THE CANARD PUSHER

NO. 14 OCT. 77

NEWS OF THE VARIVIGGEN (very vig-in) and VARIEZE (very easy)

CG RANGES

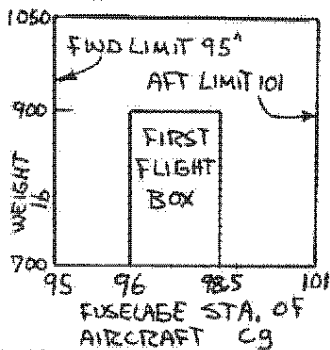
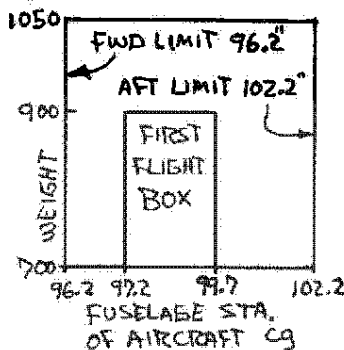
In summary, the canard trim to 142-inch span lowers the allowable pilot weights about 30 lb. If the airplane were originally designed for the O-200 with alternator the canard would have been about 142 inch span. Do not trim the canard to less than 142 inches, in hopes of using further aft cg (aft of 102.2) to balance a heavy Lycoming and a light pilot. Directional stability may degrade aft of 102.2 and the canard has not been tested for flutter at less span.

Replace cg chart with those on page 6 of this newsletter.

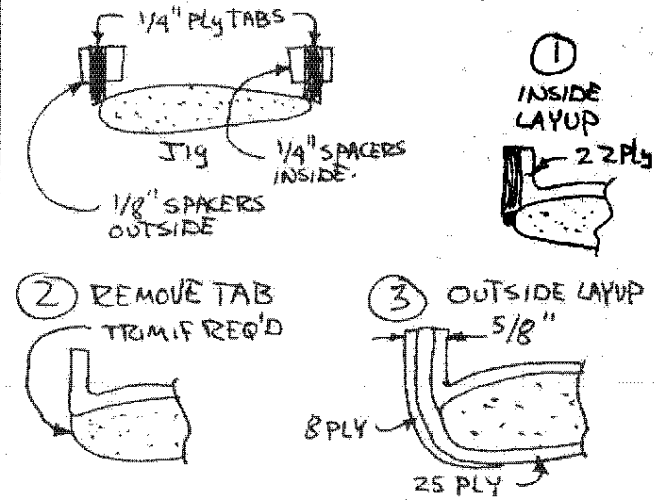
VARIABLE LANDING GEAR- We are asking all of you to make a change to the main gear mounting tabs. This change is not based on any problem with N4EZ nor any drop test result. N4EZ now has about 500 landings, some of them at gross weight and a few of them quite hard. There has been no deterioration of the gear or attachments, so it is a bit confusing to us to learn that 3 or 4 of the homebuilt Ezs now flying have had failures. One was a complete failure of the tab that allowed Cy Mehling's gear to rotate forward, dropping his airplane on its belly while taxiing. Others were discovered before they completely failed. In one case the bolt or spacer had worked in the tab enough to allow the inside and outside pad layups (page 18-2) to move relative to each other, thus partially peeling the tabs from the strut and making the strut loose. Because these failures are apparently not isolated cases but are affecting a large percentage of the builders we recommend that you update your gear to the configuration shown below before you taxi or takeoff.

The modification does two things. First it adds additional material to the tabs and second, it allows the inside and outside pads to bond directly to each other, preventing the relative motion allowed by the previous foam tab. Here's the method for original construction: make the tabs as shown on page 18-1 from 1/4" plywood, not foam. Instead of the two 3/16" spacers, make the spacers in-between the tabs 1/4" thick and the outside spacers 1/8" thick, otherwise follow step 2 exactly. Modify step 3 as follows: make only the inside layup, using 22 plies BID. Clamp lightly (too much pressure will drive out too much resin) and allow to cure. Using the tab as a guide, drill through the inside pad and trim the edges even with the tab. Now completely remove the tab and sand the faces of the inside layup dull. Do not be concerned if you have to remove a little of the gear strut to fair into the trimmed tab. Apply the outside pad layup using 25 plies all around and an additional 8 plies on each side that just lap over the leading and trailing edges. Clamp lightly and cure. Continue, following step 4. This will now result in a solid glass tab in the 5/8" gap between the aluminum extrusions.

Do not make the layup wider than 2 inches. A wide layup will stiffen the gear locally and can result in the strut peeling away due to bending loads. If your gear is already mounted, use the following procedure: saw off the bottom cover from the rear seat, back about 12". Remove the gear. Peel off the 15-ply outside layup pad (chisel and hammer.) Completely remove the foam tab. Layup about 6 plus on the face of the inside pad, butting them against the gear leg. Trim the strut as required for a smooth corner without a joggle. Layup the 25 and 8-ply outside layup as shown above. Be sure to check that you have the correct 0.6-inch edge distance all around the tab. Cy Mehling's tabs were only 0.33" at the point of failure.

Modify main gear tabs as shown in this newsletter.

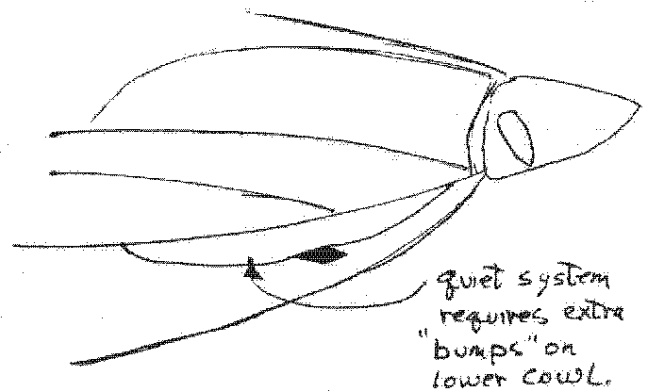
VARIEZE EXHAUST SYSTEM - As you know from CP 13, the four-post exhaust system had to be shortened to avoid vibration failures. CP 13 instructed you to shorten your system but did not have a drawing showing all details. The drawing below shows what the system looks like after shortening. Note that it must fit rather tight on the intake manifold to allow adequate cowling clearance. If you have an original-length system from mild steel, saw out a portion of the horizontal length and take it to a welder to get it welded - most auto muffler shops can do an adequate weld on mild steel tube.
